## **Access Compliance Report Public Rights-of-Way** (Curb Ramps)

Intersection ID: 26367 Main Street: BEVINGTON PL Cross Street: GLYNMOOR\_LAKES\_DR Location: SE ADA ID: 7376759A592E Ramp Type: PerpDiag Initial Pass/Fail: Fail **Overall Compliance: No** Severity Score: 18.75

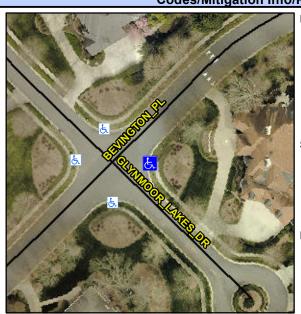
Field Measurements/Component Compliance					
Comp	Compliance Description		Comp	liance Description	Data
N/A	Ramp Length (in)	119.0	Yes	Ramp Slope (%)	6.3
No	Ramp Width (in)	33.0	No	Ramp XSlope (%)	2.5
N/A	Flare Type LT	N/A	N/A	Flare Type RT	N/A
N/A	Flare Slope LT (%)	N/A	N/A	Flare Slope RT (%)	N/A
N/A	Flare Traversable LT?	N/A	N/A	Flare Traversable RT?	N/A
N/A	Landing Length (in)	N/A	N/A	DWS Provided?	N/A
N/A	Landing Width (in)	N/A	N/A	DWS Contrast?	N/A
N/A	Landing Slope (%)	N/A	N/A	DWS Length (in)	N/A
N/A	Landing X Slope (%)	N/A	N/A	DWS Full Width?	N/A
N/A	Landing Curb? (Y/N)	N/A	N/A	DWS Offset (in)	N/A
N/A	Shared Landing?	N/A			
N/A	Gutter Ponding?	N/A	N/A	Gutter Slope (%)	N/A
N/A	Gutter Lip Ht (in)	N/A	N/A	Gutter X Slope (%)	N/A
N/A	Painted X Walk1?	No	N/A	Painted X Walk2?	No
	X Walk 1 Direction	To NW		X Walk 2 Direction	To SW
N/A	X Walk 1 Width (in)	N/A	N/A	X Walk 2 Width (in)	N/A
	X Walk 1 Slope (%)	4.0		X Walk 2 Slope (%)	0.8

X Walk 1 X Slope (%)	1.1		X Walk 2 X Slope (%)	1.9
N/A	Ramp inside XWalk1?	N/A	N/A	Ramp inside XWalk2?	N/A
	Road Slope (%)	0.7	N/A	Clear Space?	N/A
	Road X Slope (%)	1.2	N/A	Clear Space to XWalk (in)	N/A
N/A	Any Obstructions?	N/A	N/A	Storm Grate/Utility Hazard?	N/A
	Obstruction Type			Storm Grate/Utility Type	
		N/A			N/A
			Yes	Surface Condition? (G/P)	Good
COLUMN TO A STATE OF THE STATE		•	-	. ,

Possible Solutions: **Remove & Replace Curb Ramp With Two New Directional Ramps or** Equivalent. Surveyor Notes: N/A PROW/ADA: R304.5.1, R304.5.3
